Global Laser Enrichment  
 Docket Number 70-7016

**SUBJECT: GE-HITACHI GLOBAL LASER ENRICHMENT RESPONSE TO REQUEST FOR  
 ADDITIONAL INFORMATION RELATED TO NRC REVIEW OF GLE  
 ENVIRONMENTAL REPORT**

**Enclosure 1**  
**GLE Response to Environmental RAIs**

Figure 4.5(E): Age and Condition of Biotic Communities Dominated by Pine

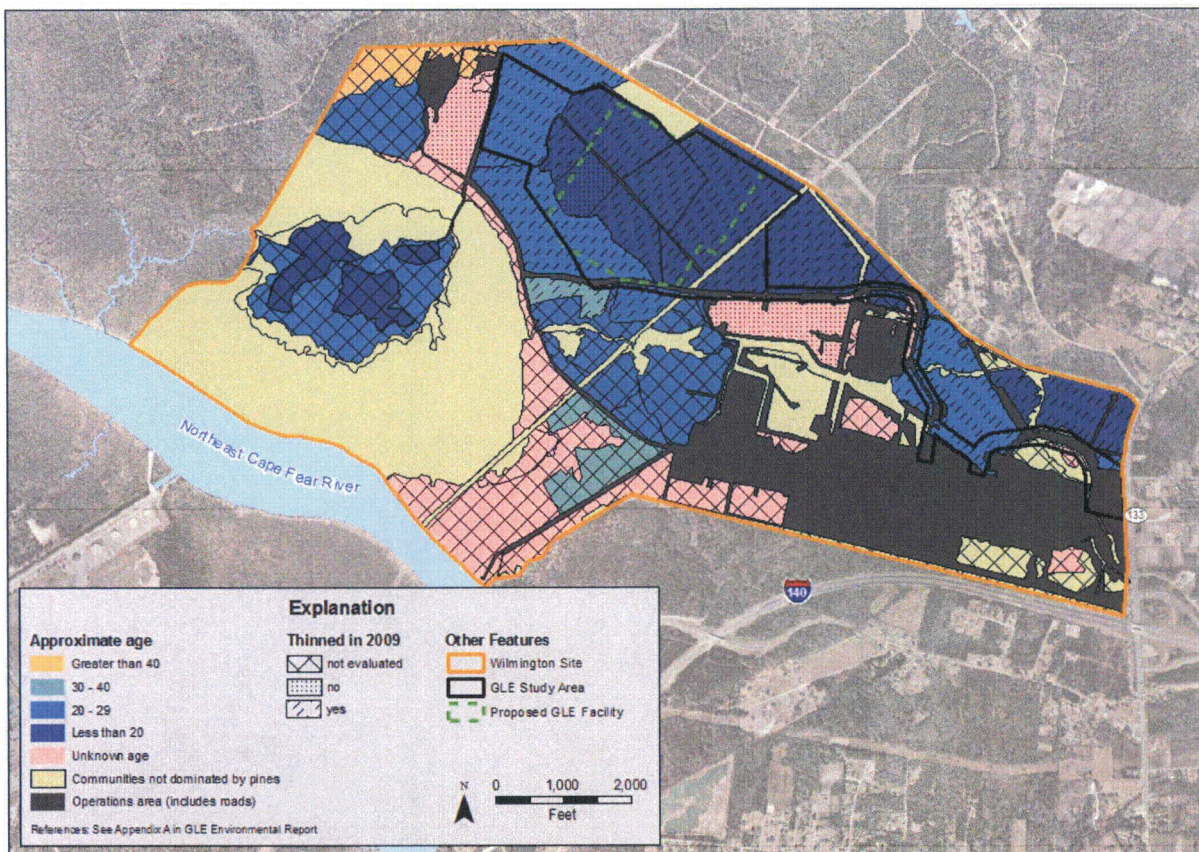
E. Provide the most recent dates and areas where logging has occurred in the area proposed for the GLE facility. Also, provide whatever similar summary data is available for logging on the Wilmington site since 1980 (approximately). This information is needed to support conclusions about the suitability of the site for red-cockaded woodpecker habitat.

Figure 4.5(E) illustrates the age of the forest communities based on the 2009 GE Forest Management Plan; however, this scale is not at a fine enough resolution to identify areas that were planted versus naturally regenerated. The area within or adjacent to the GLE Study Area was observed in October 2009 to verify which areas had received thinning treatments. In addition to being thinned, some areas received additional reduction of sub-canopy vegetation within the rows.

Figure 4.5(F). Planned Projects on the Wilmington Site.

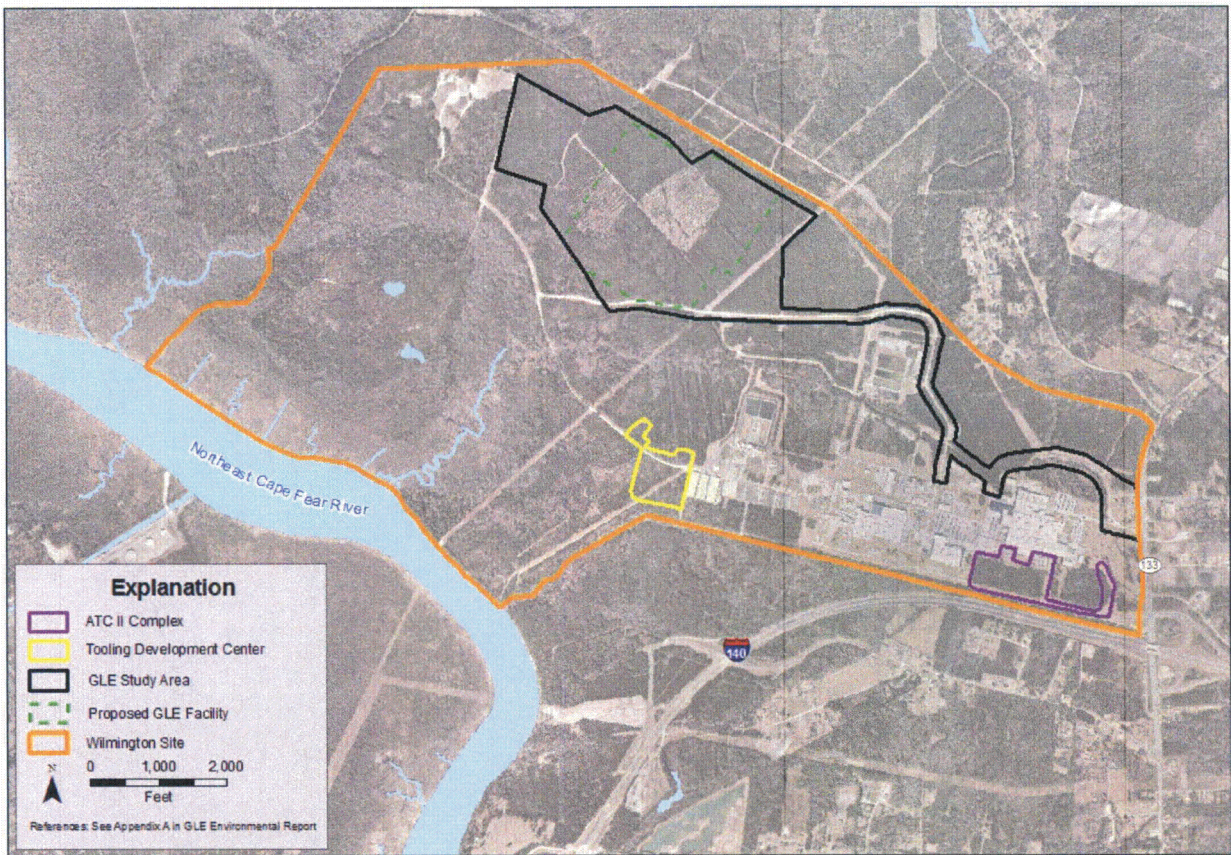
- F. Provide a figure similar to ER Figure 1-2 that shows the “30-acre” area outlines for the proposed ATC II complex and the Tooling and Development Center. This information is needed for the cumulative impacts analysis.

Figure 4.5(F) illustrates the location of the proposed ATC II Complex and the Tooling Development Center on the Wilmington Site. The ATC II complex in the southeastern portion of the Eastern Site Sector near the South Gate has impacted approximately 20.66 acres (8.36 ha) consisting of 11.30 ac (4.57 ha) of Pine Forest and less than 0.01 acres (0.01 ha) Pine-Hardwood Forest.

The Tooling and Development Center would impact approximately 16.31 acres (6.60 ha), consisting of 0.28 ac (0.13 ha) of Pine Forest, 7.27 ac (2.94 ha) of Pine-Hardwood Forest, and 6.45 ac (2.61 ha) of Pine Plantation habitat in the western portion of the Eastern Site Sector. The cumulative effect from both of these projects would be the loss of approximately 24.3 acres (9.8 ha) of habitat in conjunction with the loss of approximately 177 acres (72 ha) of habitat from the Proposed Action. Total loss of available habitat would be approximately 202 acres (82 ha), comprising 16% of the forest habitat currently on the Wilmington Site.
